## ASSESSMENT REPORT

### Shoalhaven Starches Ethanol Expansion Project Section 75W Modification (MP 06\_0228)

#### MOD 13 – Conversion of Boilers

*Shoalhaven Starches Factory*

**Figure 6 – Beverage Grade Ethanol Distillery Footprint**

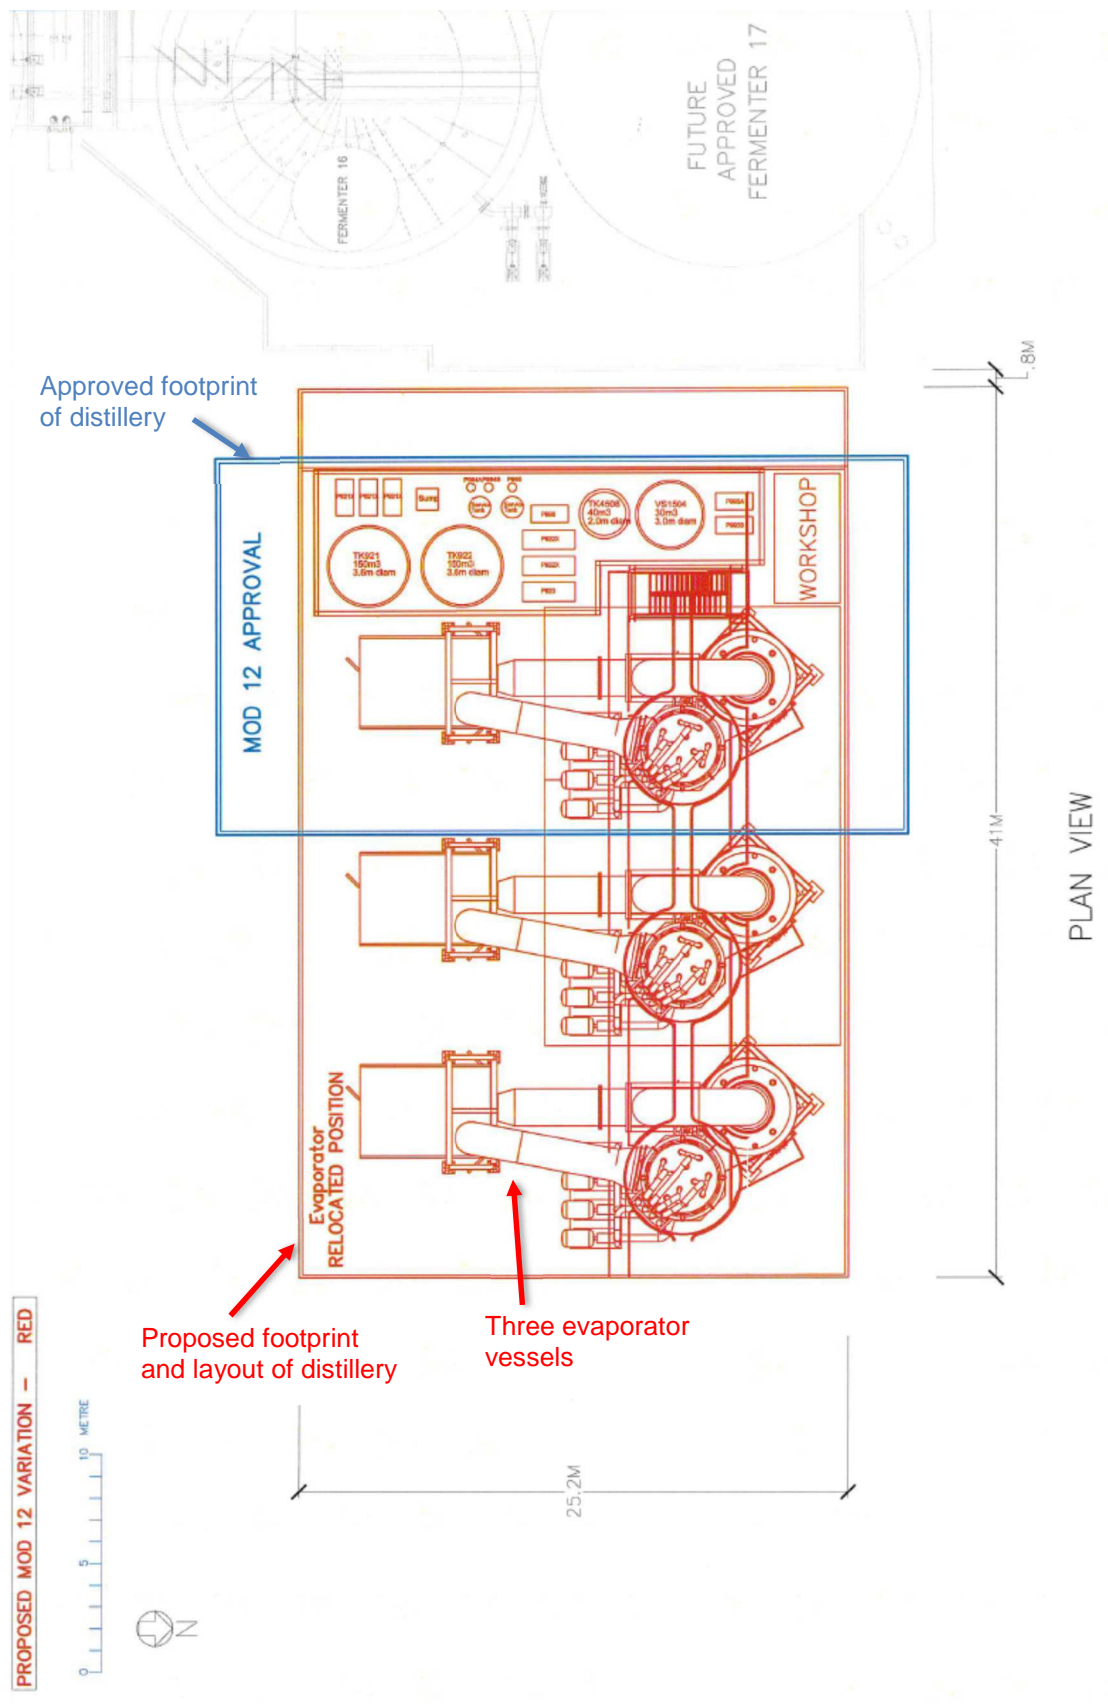
The Proponent has commenced detailed design of the distillery infrastructure and has identified a more efficient design that requires an altered footprint. There is no change to the distillery outputs or production volumes. **Figure 6** shows the proposed modified footprint compared with the approved location. The Proponent has requested the new design and altered footprint be included in this modification.

**Figure 7** – Maximum Predicted Cumulative Ground Level PM<sub>10</sub> Concentrations

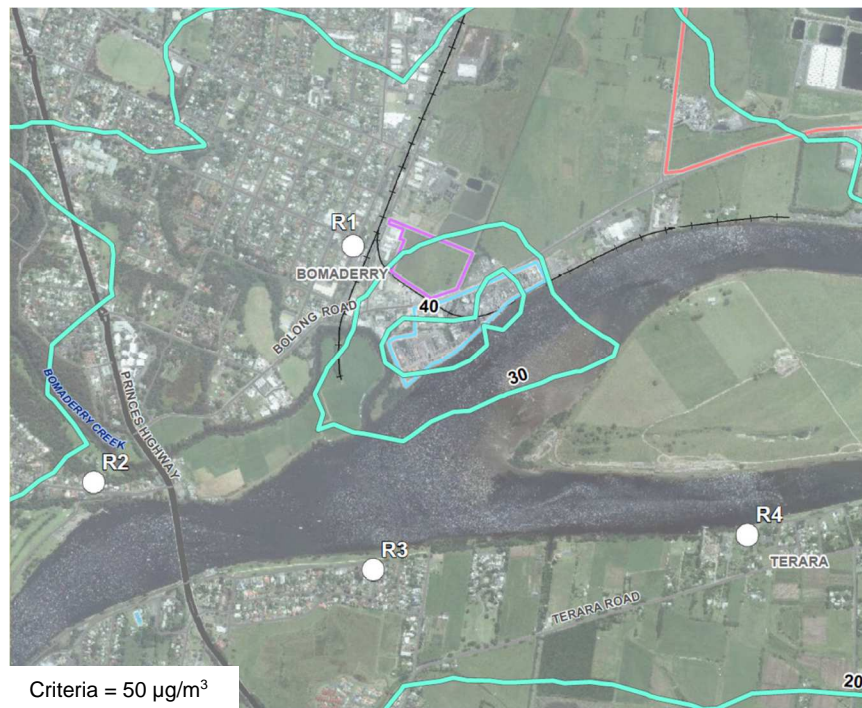
- particulate matter concentrations would comply with the 24-hour average criteria of 50  $\mu\text{g}/\text{m}^3$  for  $\text{PM}_{10}$  and 25  $\mu\text{g}/\text{m}^3$  for  $\text{PM}_{2.5}$  at the nearest residential receivers. **Figure 7** shows the maximum predicted cumulative ground level  $\text{PM}_{10}$  concentrations relative to the nearest receivers (R1 to R4)
- worst case sulfur dioxide, oxides of nitrogen and carbon monoxide concentrations would comply with the 1-hour average criteria at the nearest residential receivers
- hydrogen fluoride concentrations would comply with the 24 hour criteria at the nearest residential receivers
- volatile organic compounds and polycyclic aromatic hydrocarbons would be well below relevant criteria at the nearest receivers
- heavy metal concentrations would be below the relevant criteria at the nearest receivers.

The EPA was satisfied with the predictions of the modelling and recommended a range of conditions to manage emissions from the converted boilers. The EPA recommended emission limits and quarterly monitoring for a range of pollutants including particulates, sulfur dioxide, oxides of nitrogen, volatile organic compounds and heavy metals. The EPA recommended a post commissioning verification report including the results of monitoring and a requirement to implement further mitigation measures if the limits are exceeded.

The Department agrees with the conclusions of the AQIA and the recommendations of the EPA. The Department notes the cumulative emissions from the factory, operating with the converted boilers, would not exceed the EPA's impact assessment criteria for all assessed pollutants. The recommended conditions include a requirement for the Proponent to implement additional mitigation measures to minimise emissions if the limits are exceeded. With these controls in place, the Department concludes the air and odour emissions from the modified project would be appropriately managed to meet relevant limits.
